ADDENDUM NO.: 4.0

DATE OF ADDENDUM: November 4, 2014

**Founders Hall Renovations for Allied Health and Nursing  
Naugatuck Valley Community College, Waterbury, Connecticut  
BI – CTC – 442 – CMR**

SKETCH TITLE  
ADDITIONAL STORMWATER PIPING  
FROM CANOPY RAIN LEADERS

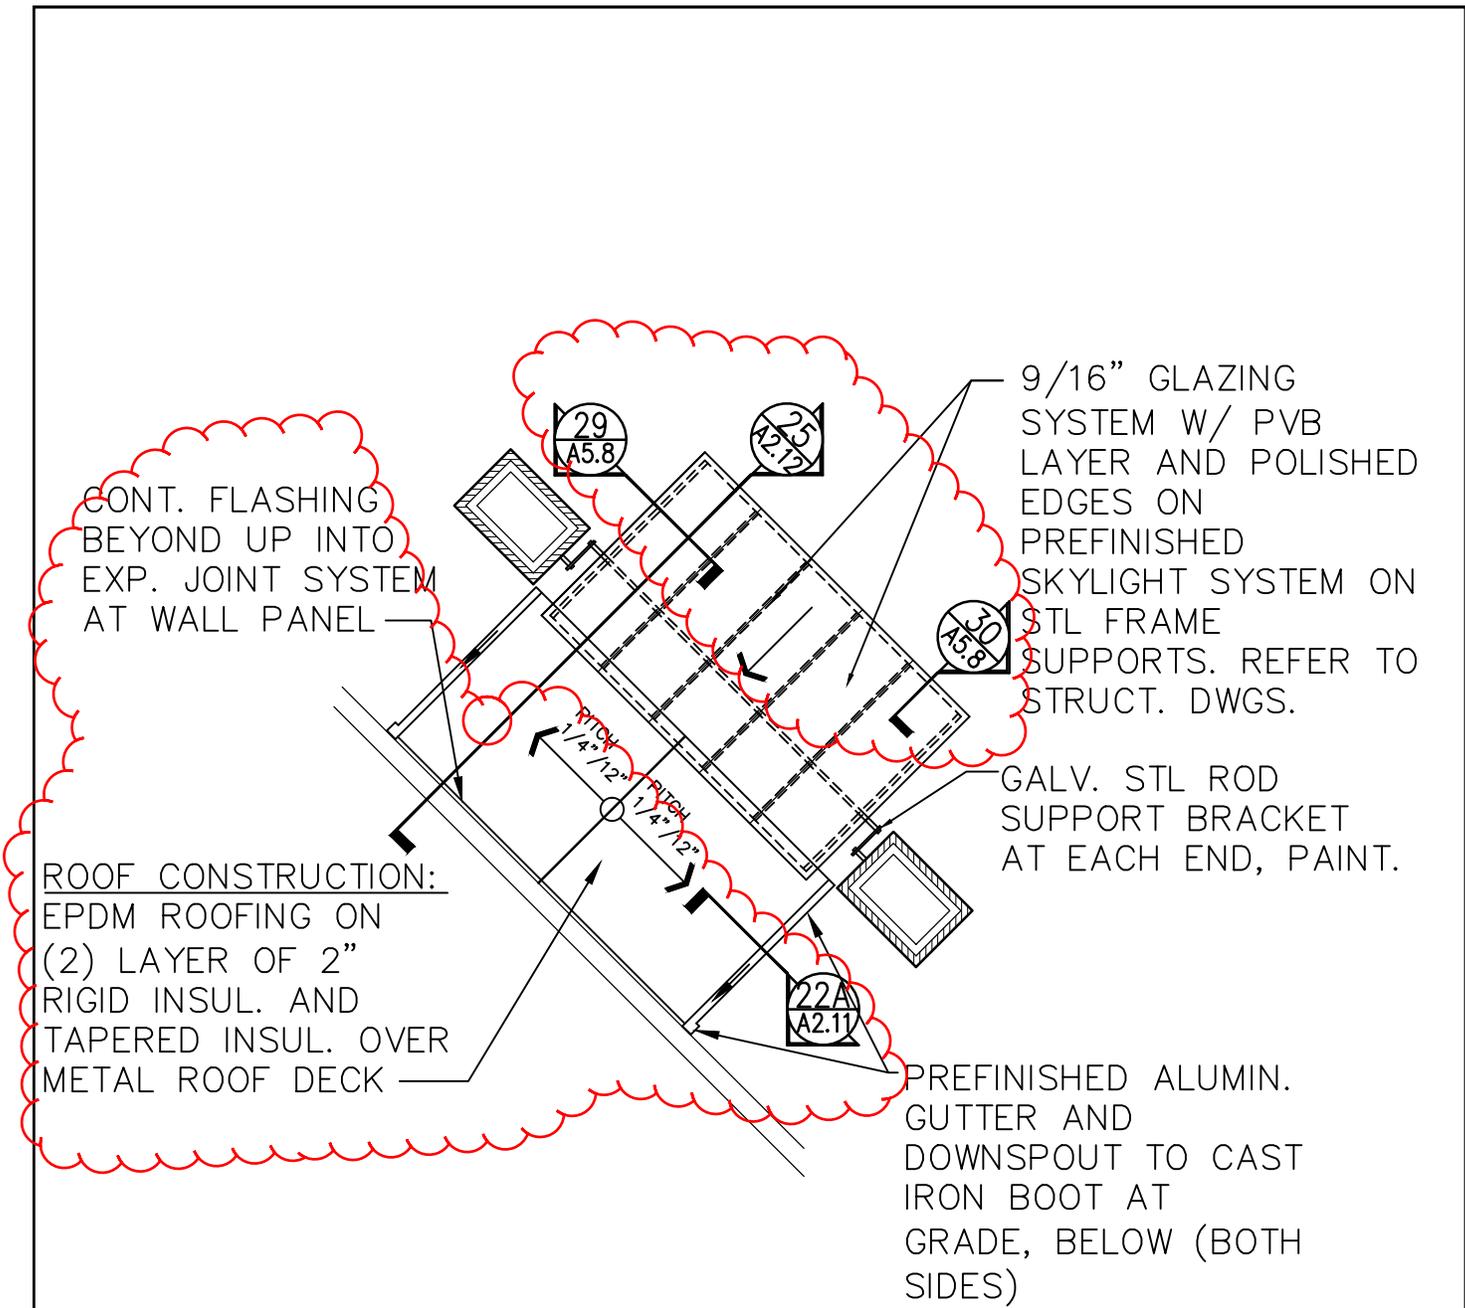
- a. At both sides of Main Entrance, **ADD** storm pipe connections to rain leader downspouts as shown on attached sketch AD4-SK-C2.1-1.
- b. **DELETE** proposed catch basin CB# C-8 at northwest corner of building.

# CHIMNEY CAP DETAIL

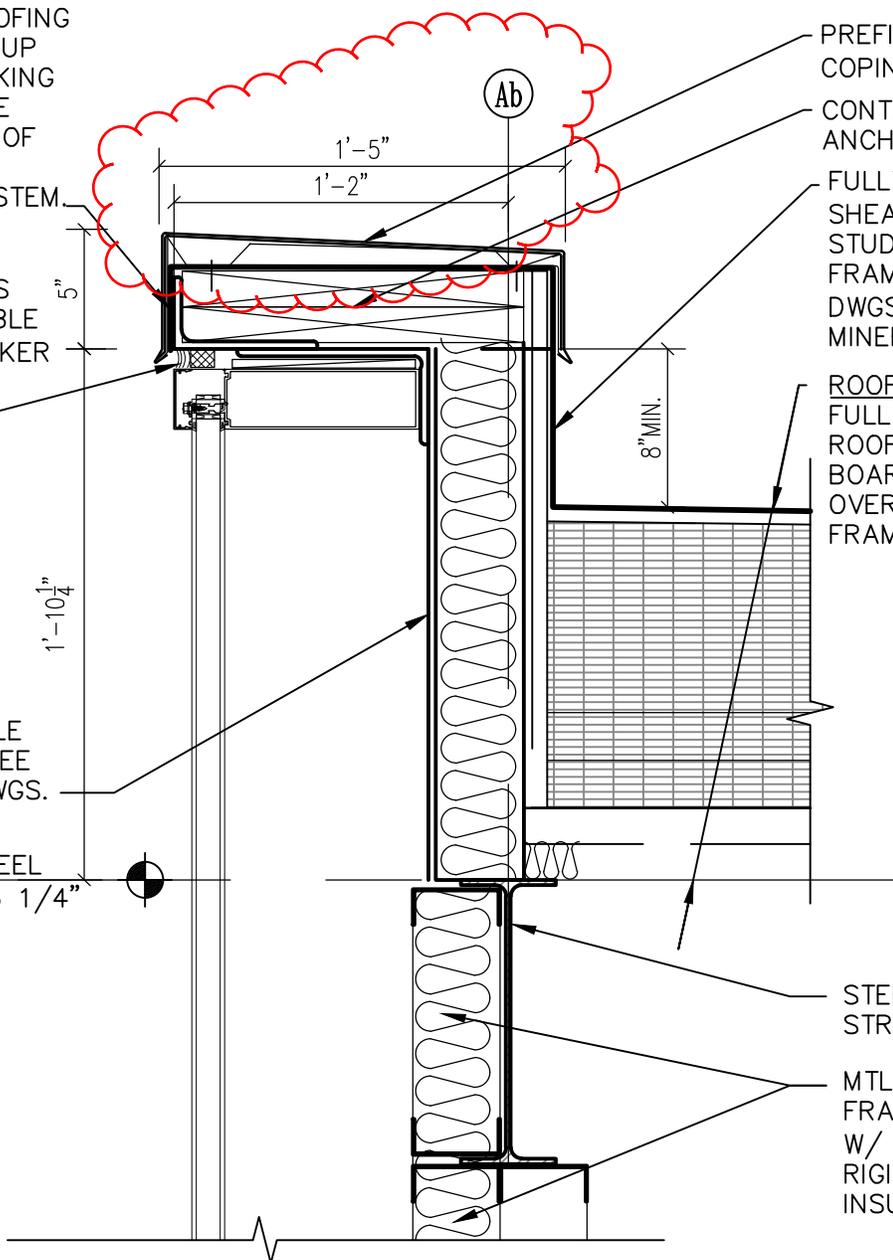
- a. At wall section 16, **DELETE** gwb and metal studs at first floor portion of wall and **REVISE** note to read “3” foil-face rigid insulation mechanically attached to face of concrete”; **ADD** gwb on 8” metal studs (with gap from exterior wall) to coordinate with floor plans.
- b. At wall section 17, **ADD** stainless steel chimney cap as shown on attached sketch AD4-SK-17/A2.9 to precast chimney cap.

**AD4-SK-28/A5.8**

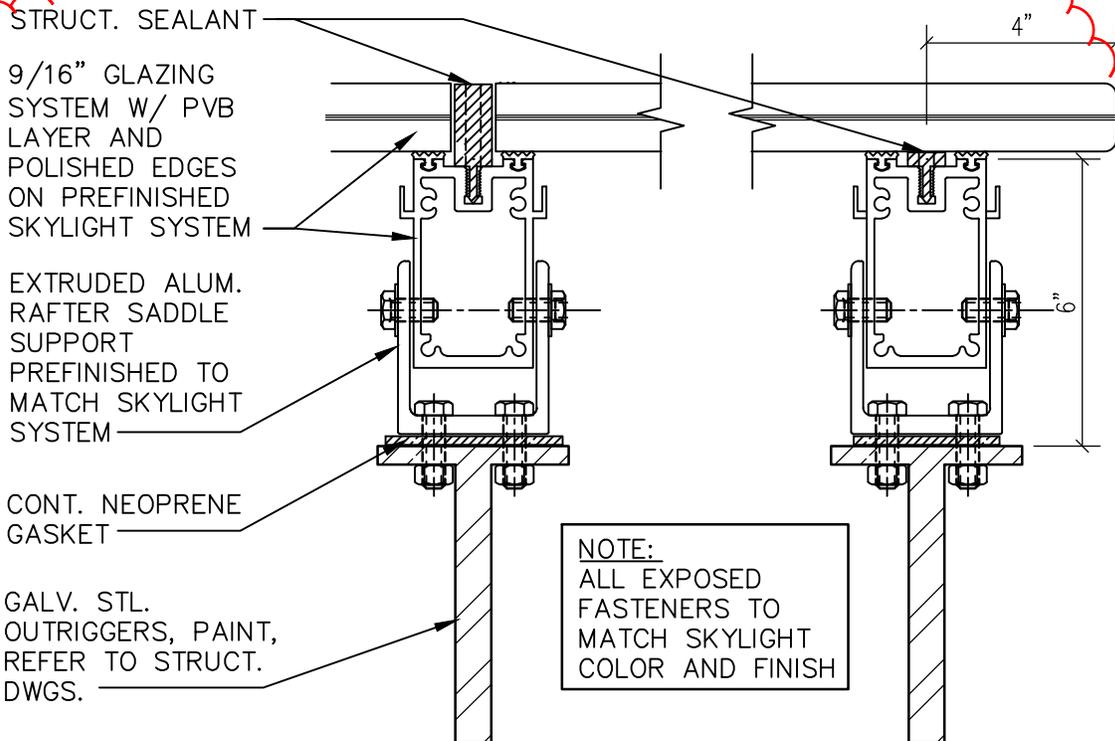
- a. **ADD** jamb detail 28 as shown by attached sketch AD4-SK-28/A5.8 entitled Jamb Detail @ Column Cover at Vestibule F149.
- b. At sill detail 26, **REVISE** slab on grade to show a 2½" depression for stone tile flooring and **ADD** note to read "2½" floor slab depression, see structural drawings".
- c. **ADD** detail 29 at glass canopy as shown by attached sketch AD4-SK-29-30/A5.8.
